**AMENDMENTS TO THE DRAWINGS**

**REMARKS**

FIG. 9

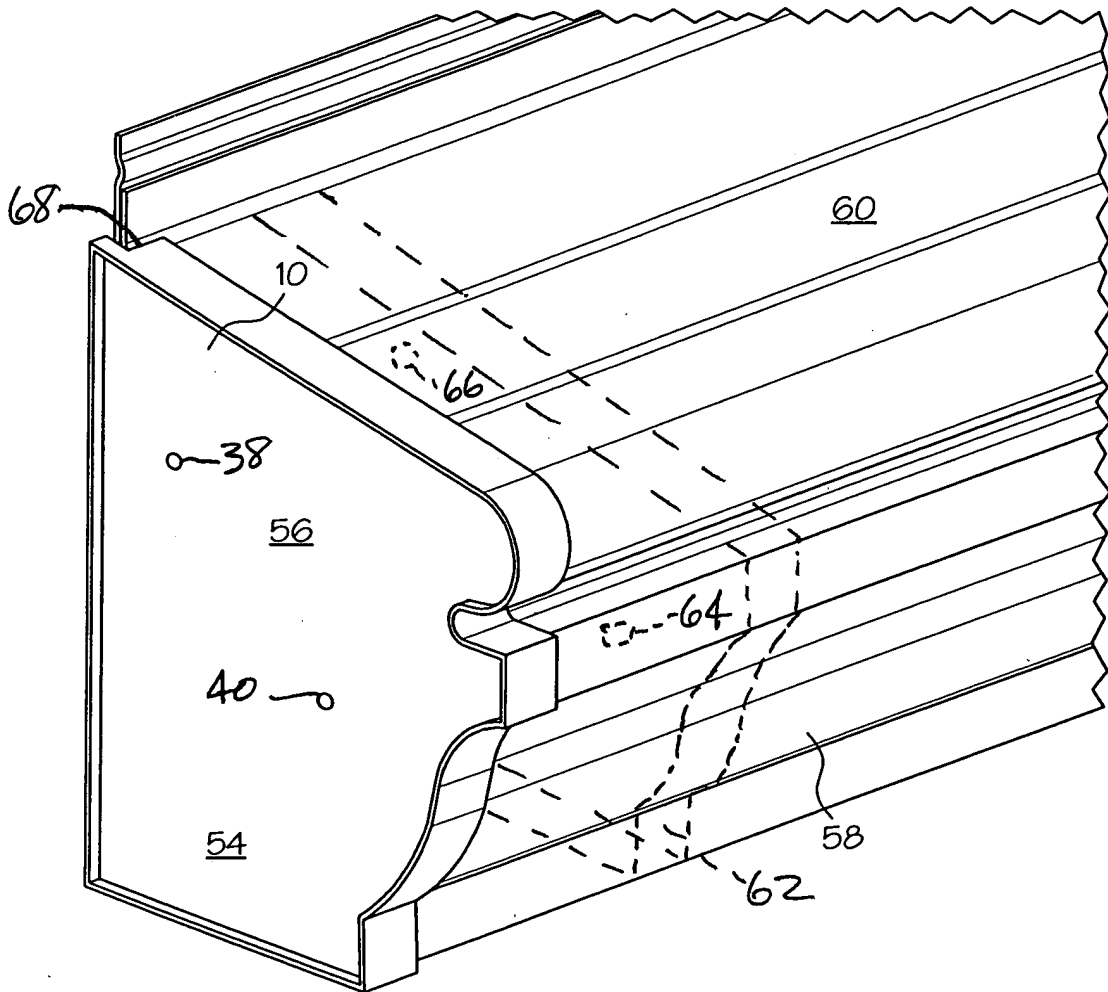
Appended hereto as an attachment is a replacement formal drawing sheet to replace sheet 3 of the drawings that were originally included in the application. The replacement sheet shows the bracket in dashed lines, it identifies by reference numerals the apertures that are involved in the interconnection of the end cap with the bracket, and it also identifies the gap recited in claim 7.

In this Amendment specification paragraphs [0021], [0023], and [0024] are amended for clarification purposes. Sheet 3 of the drawings, containing Figure 9, has been amended to identify the bracket 62, the gap 68, apertures 38 and 40 of end cap 56, and respective associated apertures 66 and 64 in bracket 62. The showing of the bracket is based upon the originally-filed specification, paragraphs 0021 and 0024, which each disclose a bracket, its position in the gutter and its connection with end cap 10 by connecting screws that pass through apertures 38, 40 of end cap 10 and into apertures 66, 64 in bracket 62. No new matter has been added to the specification because the amendatory matter is based upon the application as originally filed, including the specification, claims, and drawings.

The drawings were objected to on the ground they did not show several of the elements recited in the claims. In that regard, the support bracket is shown in amended Figure 9. The first connection means is shown in the drawings as walls 22 and 32, 24 and 34, and 26 and 36, the outer and inner peripheral walls, which also define therebetween a connection slot, as described in paragraph 0020. The gap is shown in amended Figure 9 and is identified in amended paragraph 0024, in which the amendatory matter constituting the last sentence of the paragraph is based upon claim 7 as originally filed. The first gutter-trough closure region is shown in Figure 9 as region 54 and the second closure region as region 56. It is believed that one having only ordinary skill in the art would be able to comprehend the nature, function, and structure of the invention from the drawings and the verbal description contained in the application.
